From: Jamie Verstappen
Sent: 17 August 2021 16:58
To: Mark Brown
Subject: FW: South West Stage 1 - Street Tree Query

From: Tim Scott
Sent: Monday, 16 August 2021 3:23 pm
To: Jonathan Crawford; Michael Warner
Cc: Lindsay Wilson; Jamie Verstappen; Sarah Crawford
Subject: RE: South West Stage 1 - Street Tree Query

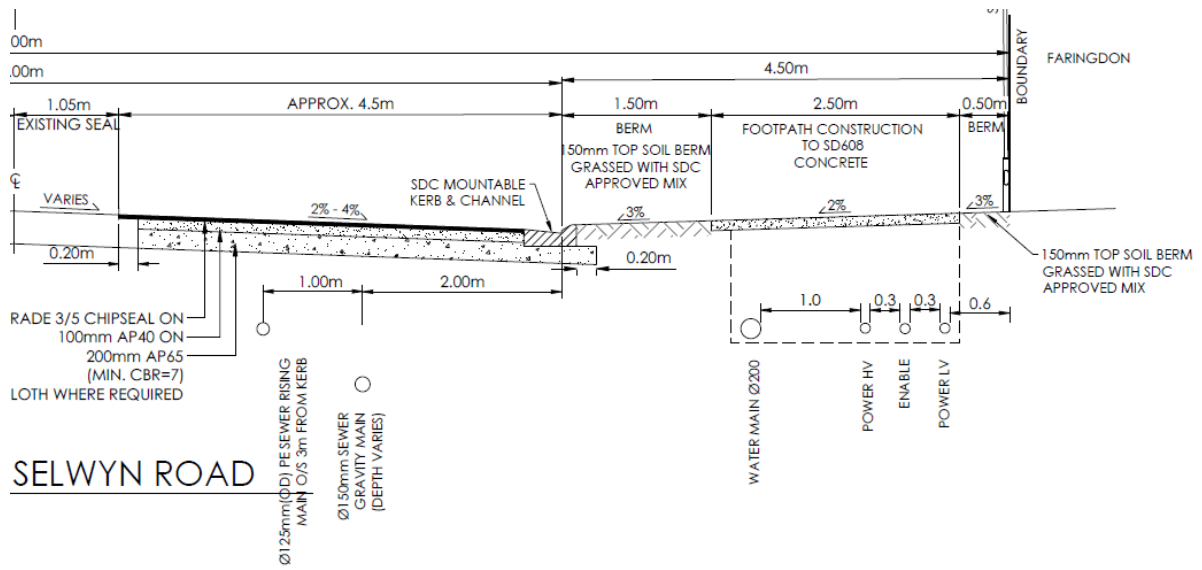
We could increase the actual berm width (from back of kerb to footpath) to 1.5m by moving the footpath back towards the boundary by 150mm. Would this make the difference? Assume a small street tree would only be suitable at 1.5m. If so are there any small species you recommend?

Would you consider street trees suitable in the below 1.5m berm width noting the actual grass berm width is 1.35m from back of kerb to footpath?

Thanks for the confirmation, yes approval to proceed on condition these are all Magnolia Kobus.

See if you can source some Magnolia Kobus they are tiny and do very little root damage and should work in that situation.
